SUBMISSION NO.1

STATEMENT
FOR MEMBERS OF THE PARLIAMENTARY JOINT STANDING COMMITTEE
ON THE NATIONAL CAPITAL & EXTERNAL TERRITORIES

Roundtable Public Hearing
Griffin Legacy Amendments 56, 59, 60 and 61 to the National Capital Plan

Prepared by Professor James Weirick
President, Walter Burley Griffin Society Inc.
140 Edinburgh Road
Castlecrag, NSW 2068

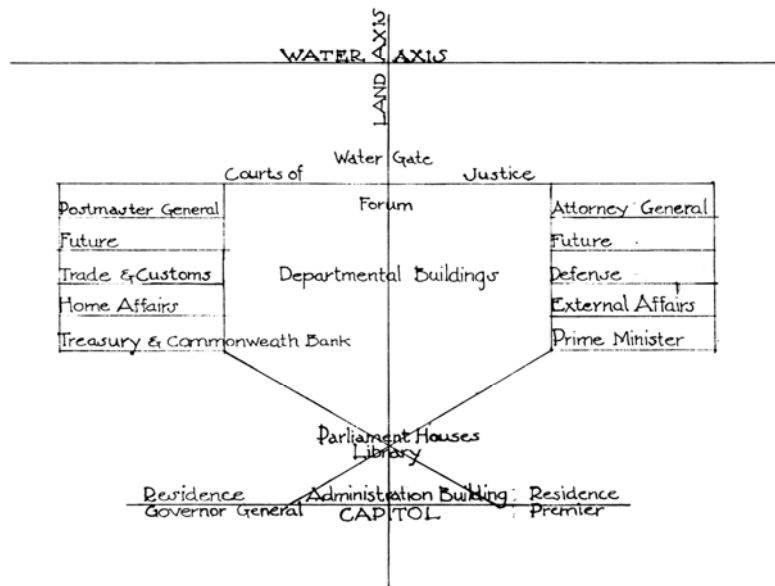
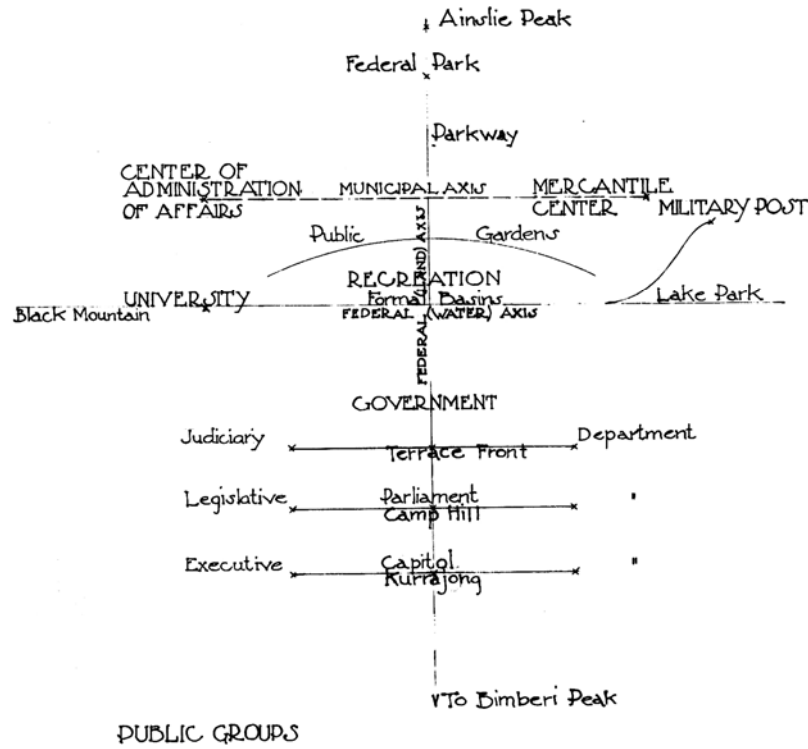
- 2.19 Griffin's symbolic framework was clearly shown in diagrams he submitted with his competition entry of 1911-1912, and published in the 'Report Explanatory' of his 1913 Plan (see figures 1 & 2 attached to this statement).

- 2.20 These 'Diagrams of Representative Democracy', to use a convenient term, need to be included in Amendment 56 to the National Capital Plan to show how to refocus the symbolic framework of Canberra within the National Triangle bounded by Constitution Avenue, Commonwealth Avenue and Kings Avenue.

To refocus the symbolic framework of Canberra, Walter Burley Griffin’s ‘Diagrams of Representative Democracy’ (figures 1 & 2) must be included in the National Capital Plan to evaluate all proposals for the Central National Area against the true substance of the Griffin Plan.

Figure 5. National Capital Authority, Aerial perspective of the West Basin Precinct, 2004 – note the tree-fringed foreshore and the grassed amphitheatre at Acton in the foreground (Source: NCA, *The Griffin Legacy*, 2004, foldout sheet after p.173).

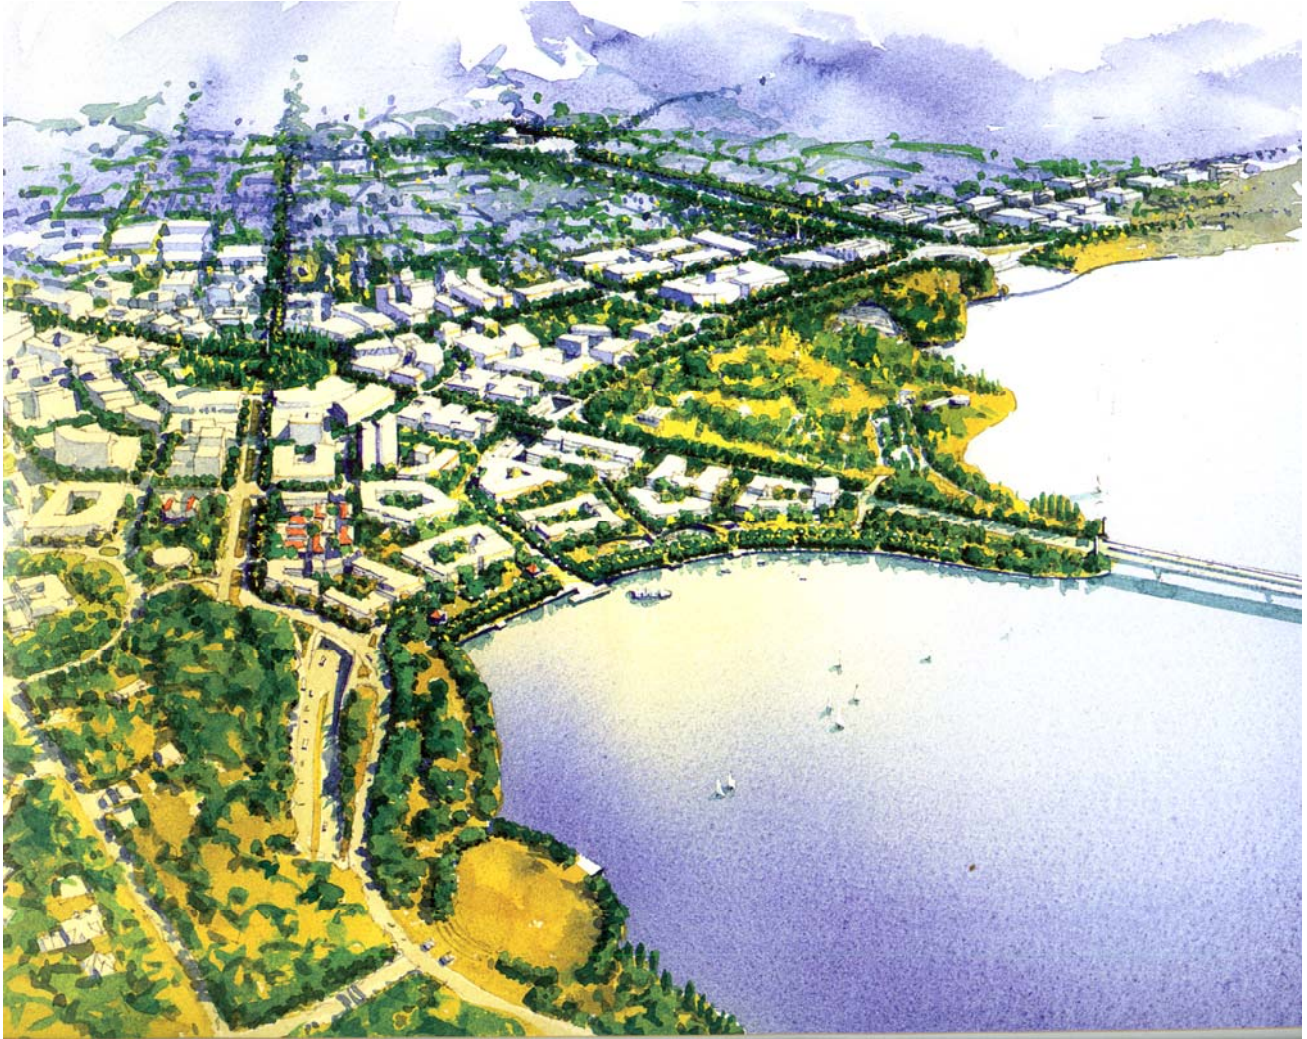
- 5.44 Something of this idea was shown in the 2004 NCA *Griffin Legacy* document (figure 5) although at the wrong level – the water's edge, not high on the ridge – and isolated from the main part of the ANU campus.

- 5.51 The key to achieving this outcome is to zone the foreshore 'Open Space/Waterfront Promenade' all the way around West Basin, i.e. remove the 'Land Use C' zoning of the Acton Peninsula frontage, remove the convention centre/hotel proposal from contention and return this section of the West Basin scheme to the 'green' condition shown in the 2004 NCA *Griffin Legacy* document (figure 5).
